# MEMORANDUM

**To:** Salt Lake City Historic Landmark Commission

**Re:** Modifications to PLNHLC2021-00967 New Construction and PLNHLC2021-00966 Special Exception at 237 N. Almond Street

Proposed streetscape and site plan:

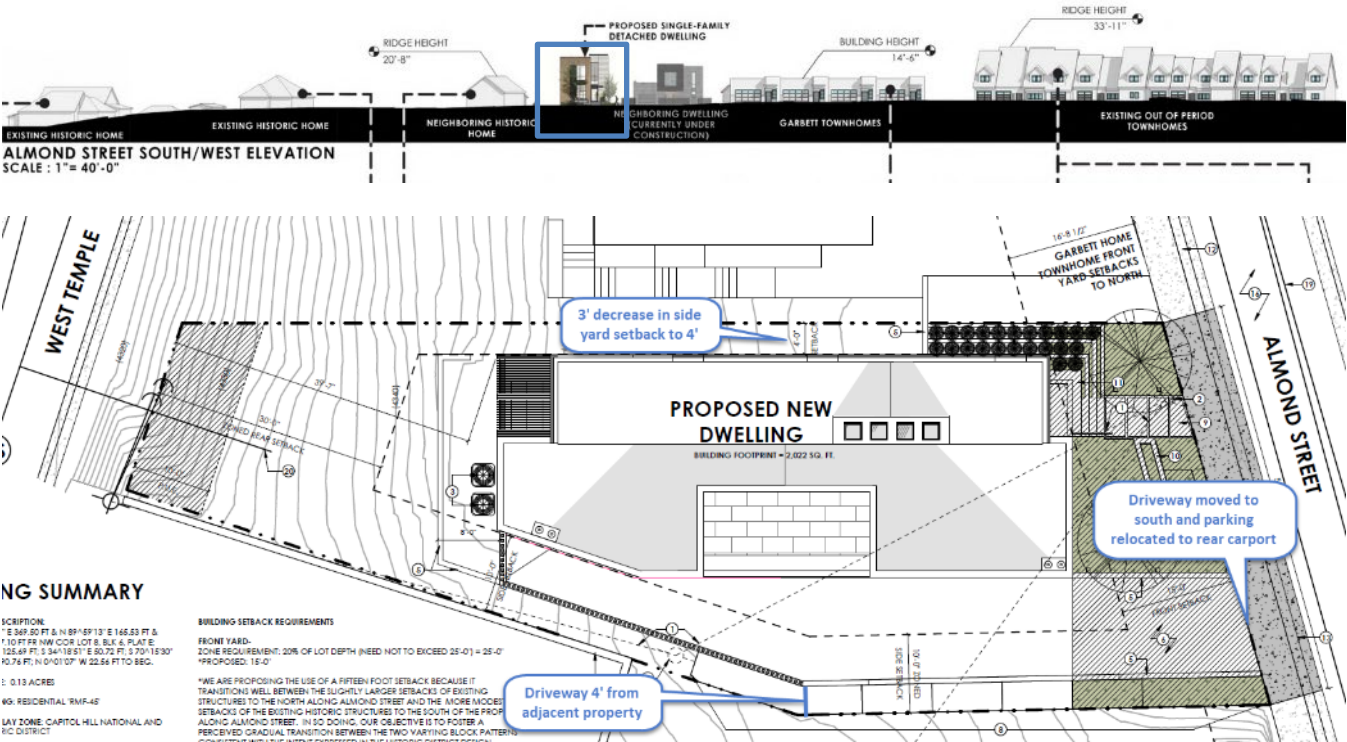
The construction costs for the dwelling came in higher than expected and the applicant is requesting modifications. This includes a small reduction in the overall square footage, changes to the design, removal of the street-facing tandem garage and replacement with a two-car carport to the rear. Additionally, the applicant is requesting a change to the previously approved modification of the north side yard setback. The request is to decrease the north side yard setback from 7 feet to 4 feet (10 feet required). The applicant is requesting a new modification to reduce the distance of the driveway from the adjacent property line from the required 6 feet to 4 feet.

- 1) The applicant is requesting a modification in the front yard setback from 25' to a minimum of 15' (this request is unchanged from the approval).
- 2) The applicant is requesting a modification in the north side yard setback from 10' to 4'.

This is an increased reduction from the approved 7'. The proposed dwelling is approximately 28' wide. The lot is approximately 50' and the required 10' setback would result in a narrower façade and living space. The 10' setback in this zoning district is required for uses other than single-family attached and multi-family dwellings. The proposed 4' side yard setback on the north, with a 10' setback on the south, is equal to the setback required for single-family dwellings in less intensive residential districts. The result is that the rear of the proposed dwelling would be approximately 13' from the side of the approved dwelling to the north. This reduction allows for the 12' wide driveway to the south of the dwelling, which also accommodates the removal of the garage on the front. The requested modification is supported by staff.

- 3) The applicant is requesting a new modification from the original approval for the distance of the driveway from the adjacent property line from the required 6' to 4'.

The proposed modifications remove the street-facing tandem garage and add a carport to the rear. The carport is accessed from a driveway to the south of the dwelling. 21A.44.020.F.7.a.2 requires a driveway to be a minimum of 6' from the property line. The proposed driveway is the minimum 12' width. The reduction to 4' from the property line places the driveway approximately 12' from dwelling to the south at the closest point, which is the rear of the dwelling.

Proposed front elevation:

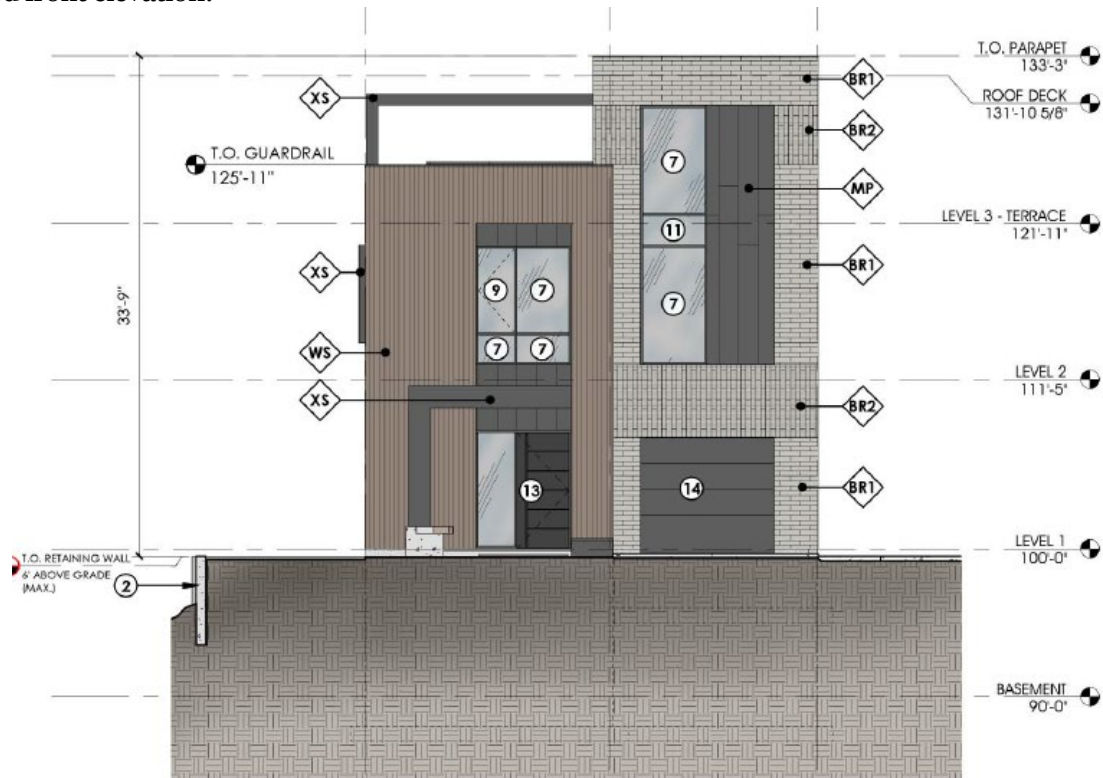
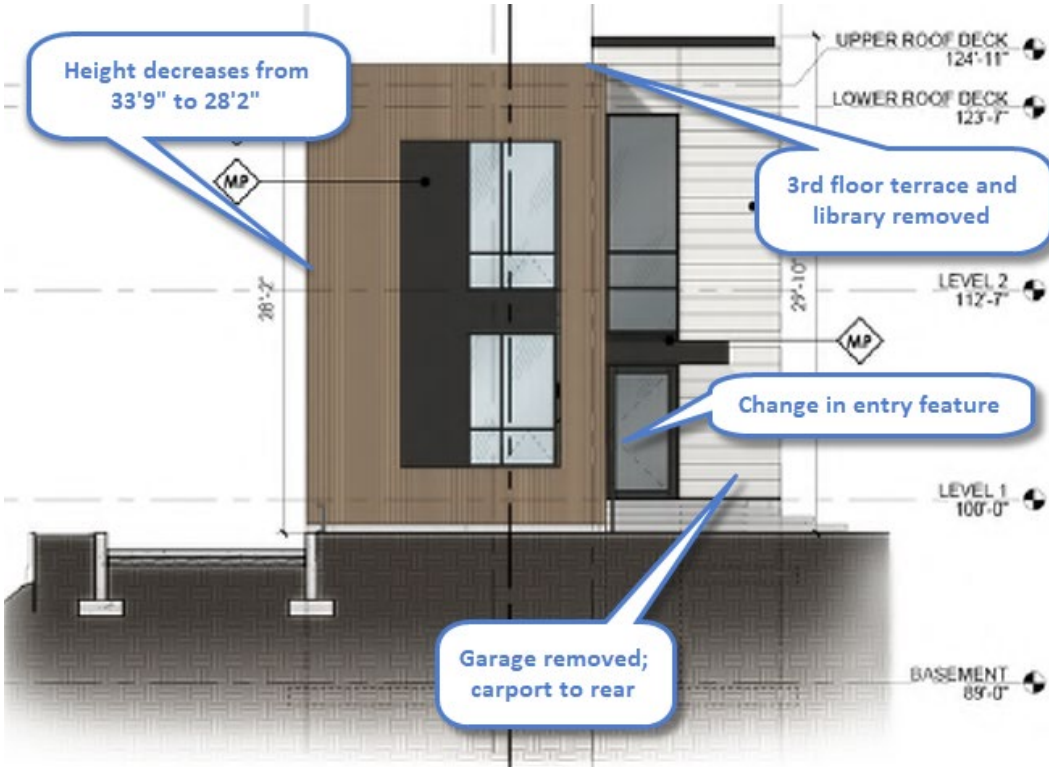
The applicant is proposing significant changes to the design of the building. These changes are identified above on the elevations. The front elevation changes are significant since the proposal:

- Removes the street-facing tandem garage and adds a carport to the rear
- Replaces the brick veneer with glass fiber reinforced concrete (GFRC) panel
- Removes the third-floor library and terrace and decreases the height of the structure 5'7" to a height of 28' 2"
- Simplifies the front entry canopy to a projecting canopy
- Changes the front door to a wood door with a full, single-lite and removes the sidelight to the left of the entry

Proposed side (north) elevation:

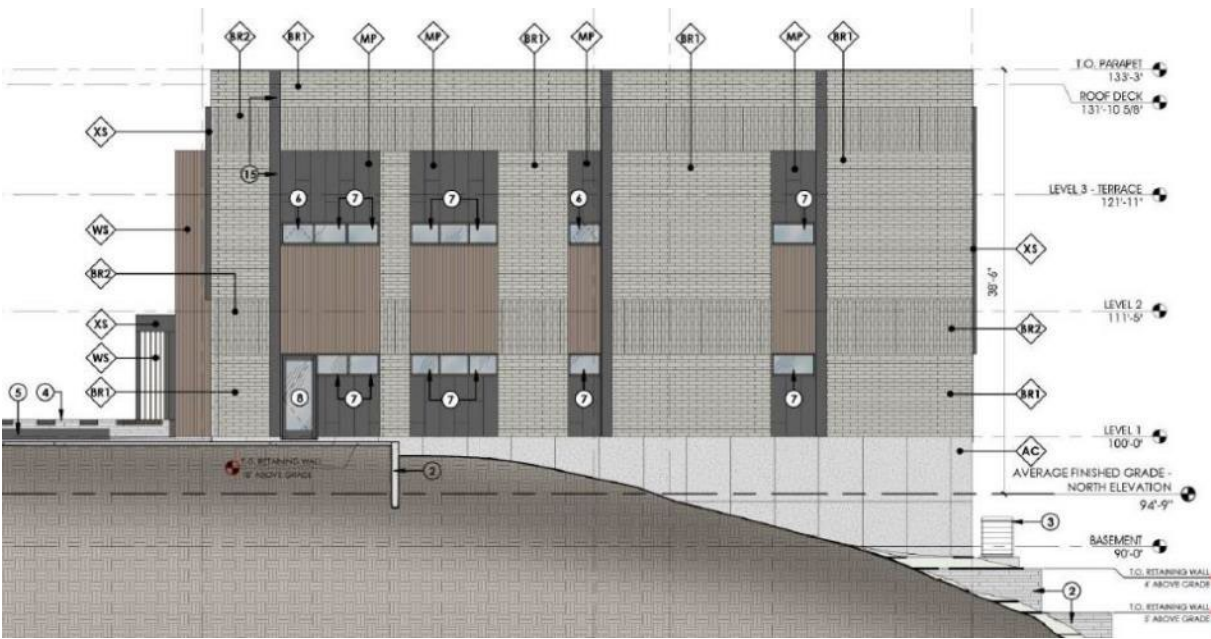
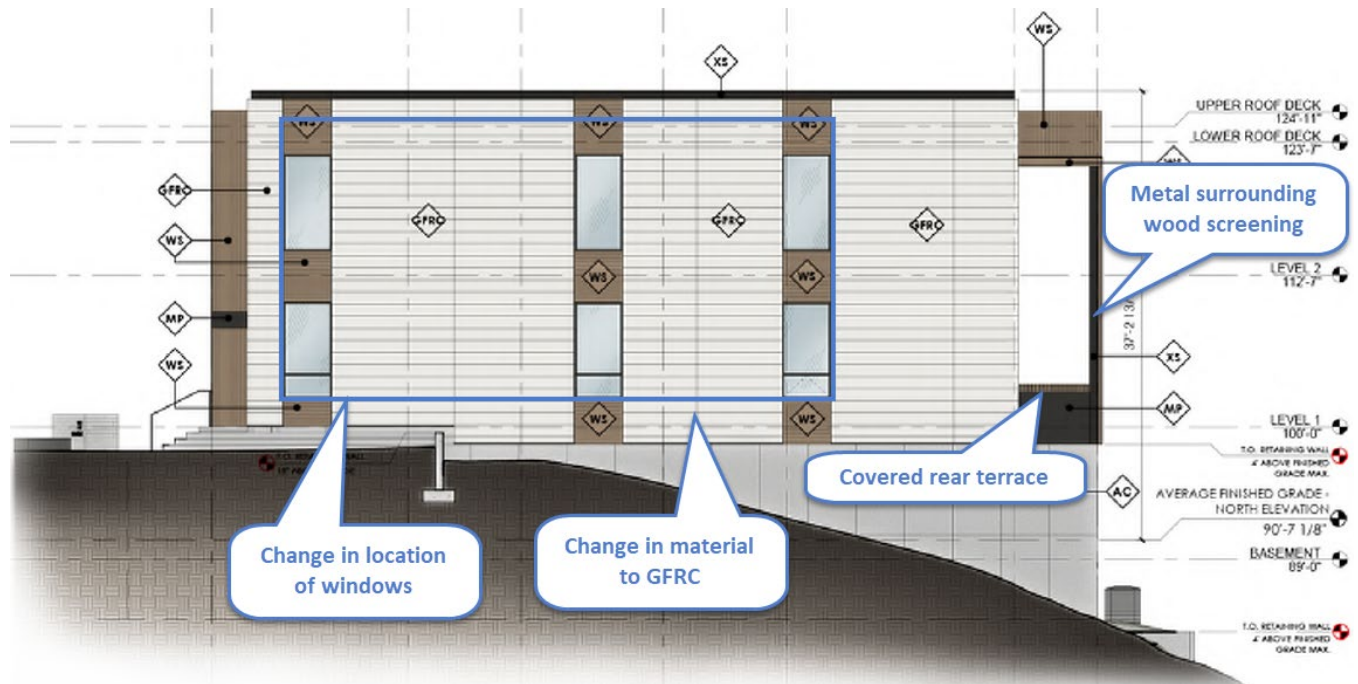
On the north elevation, the proposal changes the orientation and location of the windows. They increase in size substantially. The primary material on this façade changes from brick veneer to GFRC. For the south elevation, there are changes in the window size and location. The second-floor recessed balcony increases in size. There is a two-car carport and entry on the lower level. The refuse and recycling storage is moved from the north setback to the carport. On the rear, the first-floor terrace encompasses the width of the façade and is screened with wood siding. With the addition of the driveway to the carport, there is a 7' retaining wall along the west side of the driveway. It is topped with an approximately 2' metal railing that extends along the south side of the driveway.
